NAVIGATION - GDL 69 SXM DATA LINK UPDATE

525B (Citation CJ3+)

SB525B-34-39
Page 1 of 5

Figure 1. (Sheet 1)

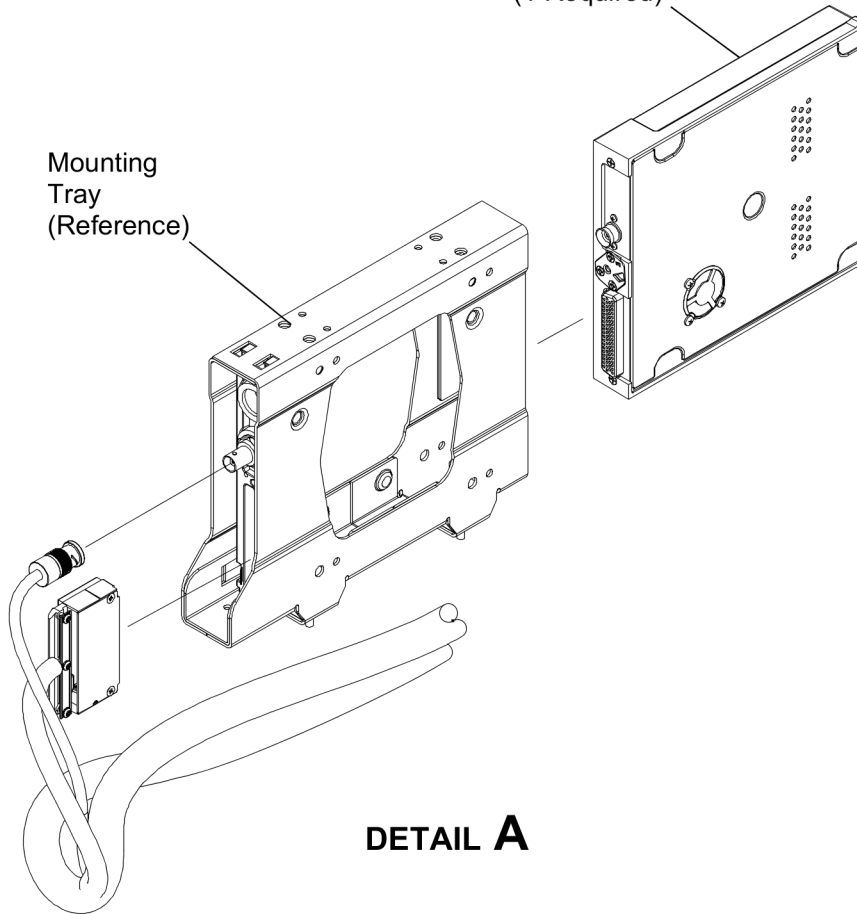
3. (Refer to Figure 1, Detail A.) Install the new 011-03177-15 GDL 69 HW SXM Data Link. (Refer to the Model 525B Maintenance Manual, Chapter 34, Garmin GDL 69A/69A SXM Data Link System - Maintenance Practices (Airplanes -0057 and -0451 and On.)

011-03177-15
GDL 69 SXM
Data Link
(1 Required)
